Revision History

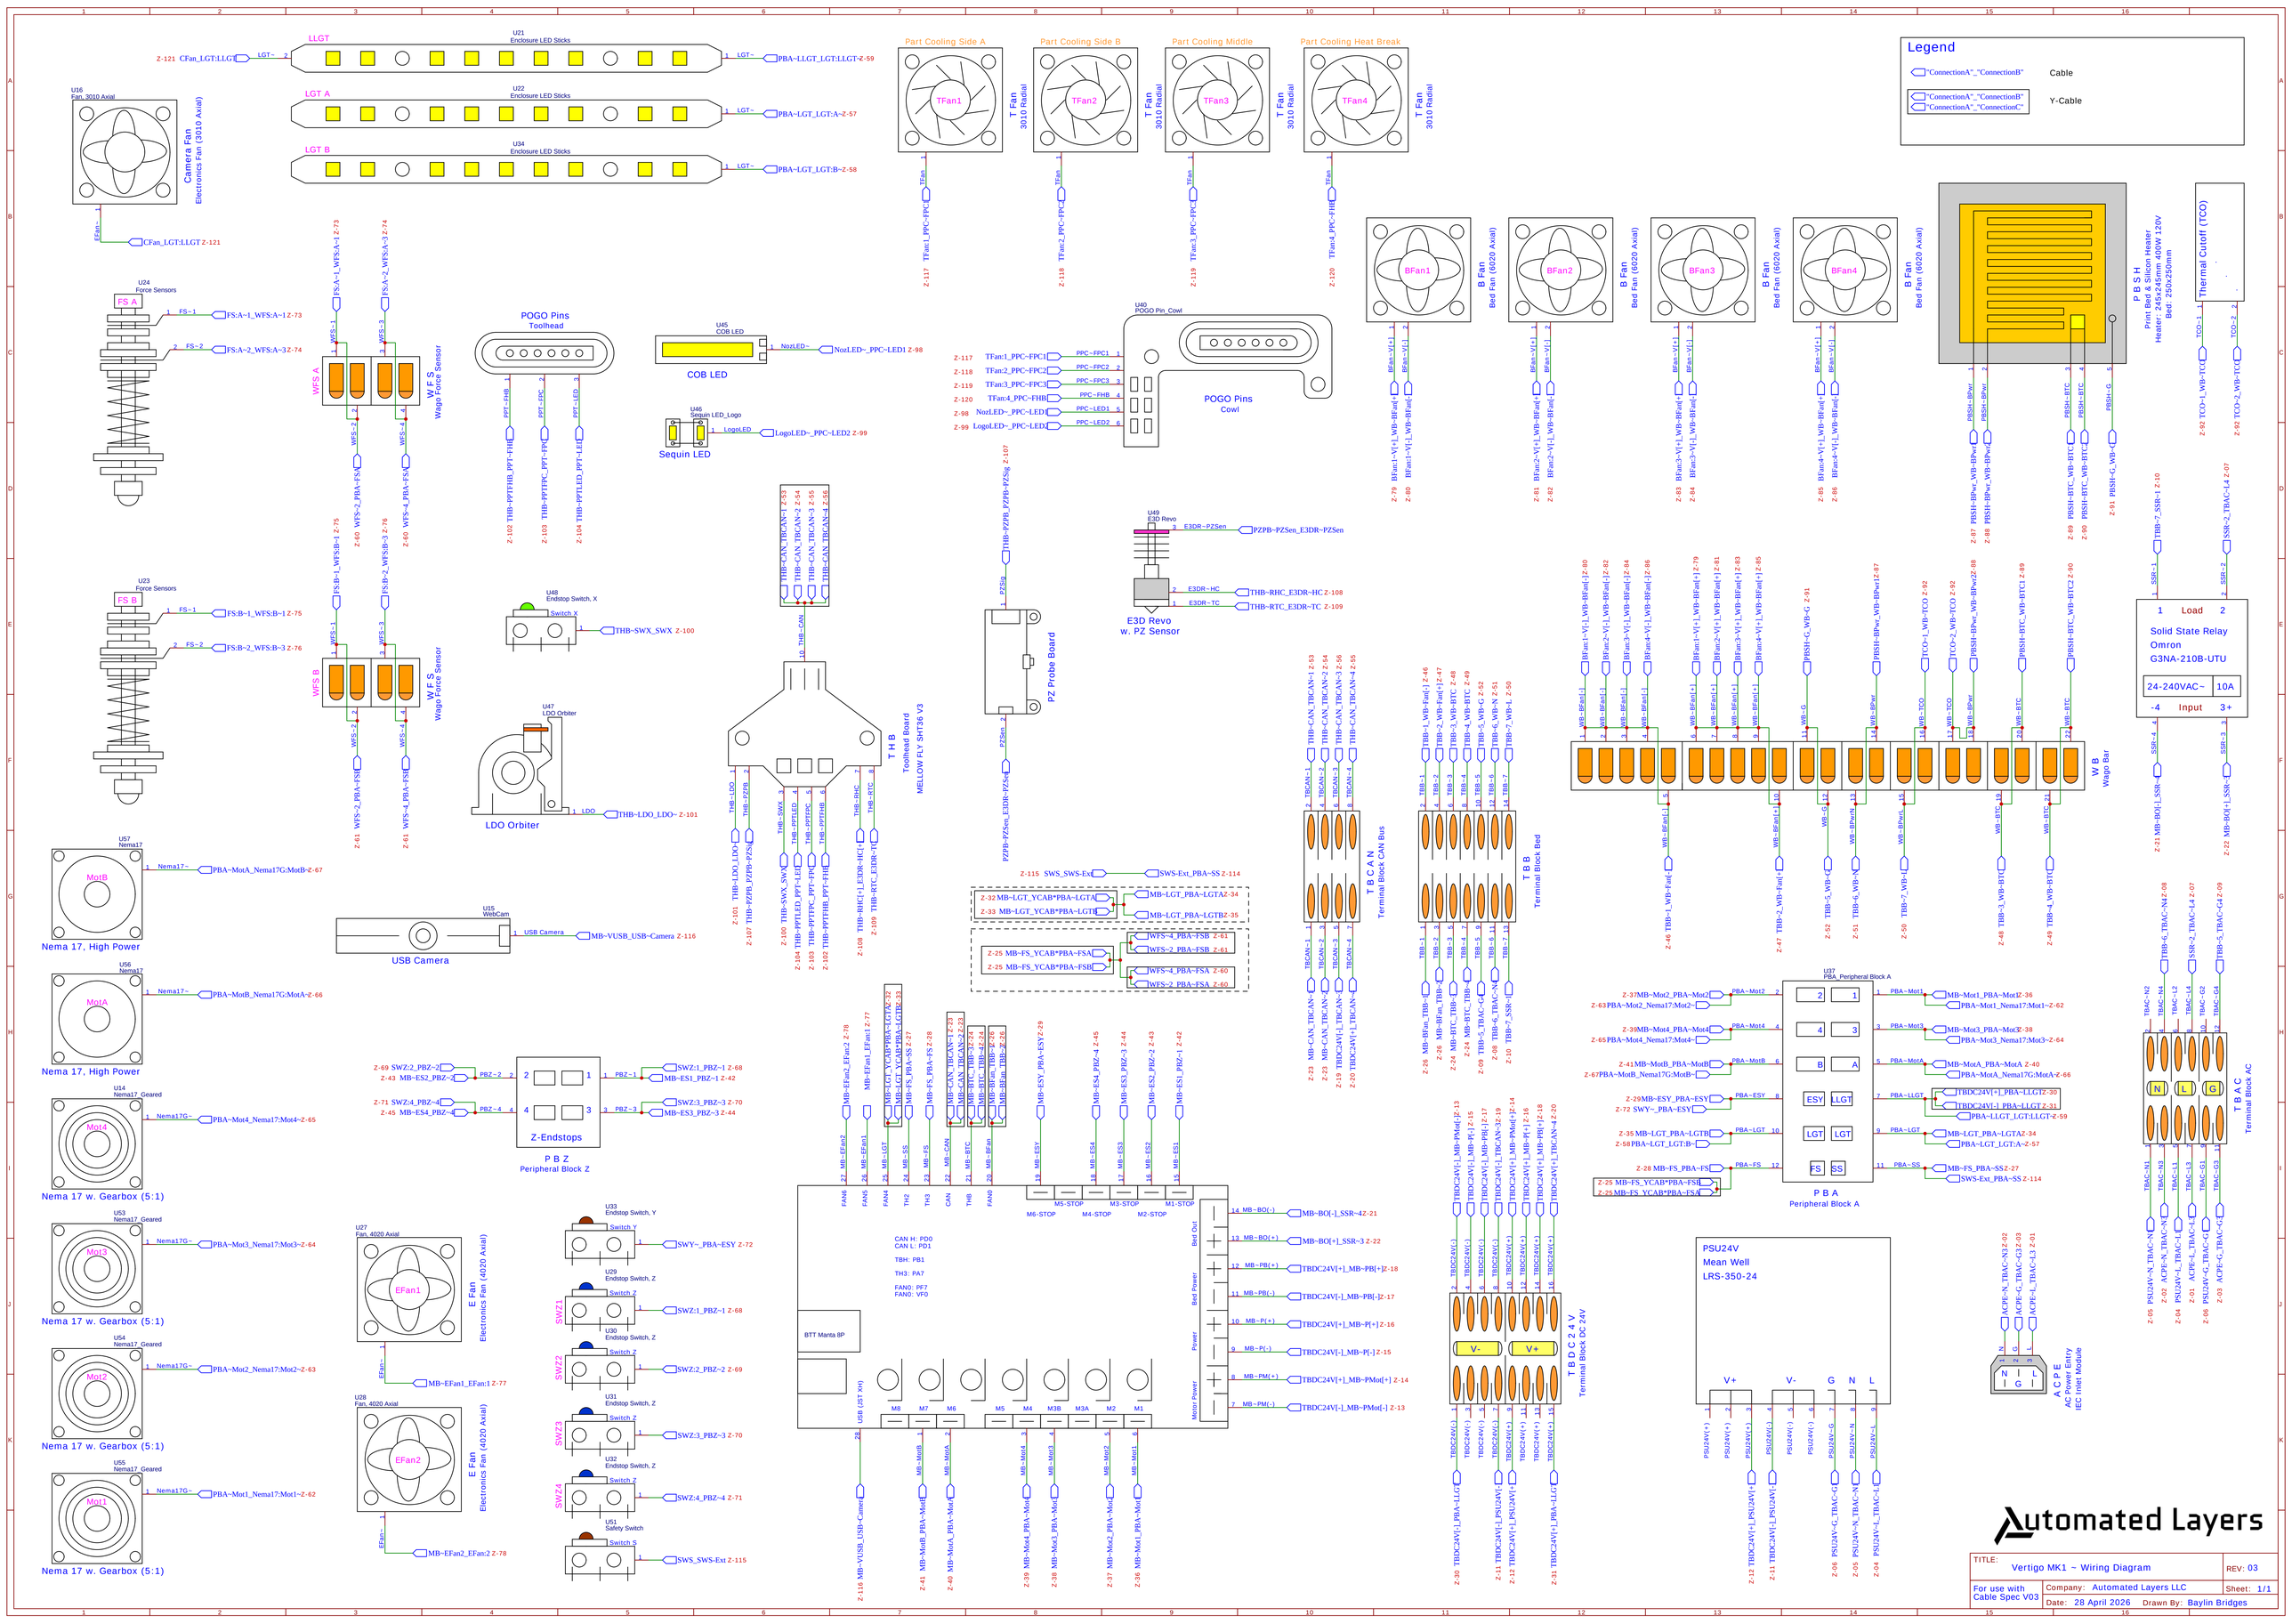
Rev	Note
01	Initial Release
02	Swapped positions of Z-30 and Z-31, error from initial release.
03	Swapped positions of Z-55 and Z-56, cable spec Rev03 change to match supplier drawing. Component Z-114 changed to Z-115 to match cable spec, error from initial release. Code Z-114 reintroduced as an extension cable for Z-115 component, safety switch. Schematic Label changed for Z-114.
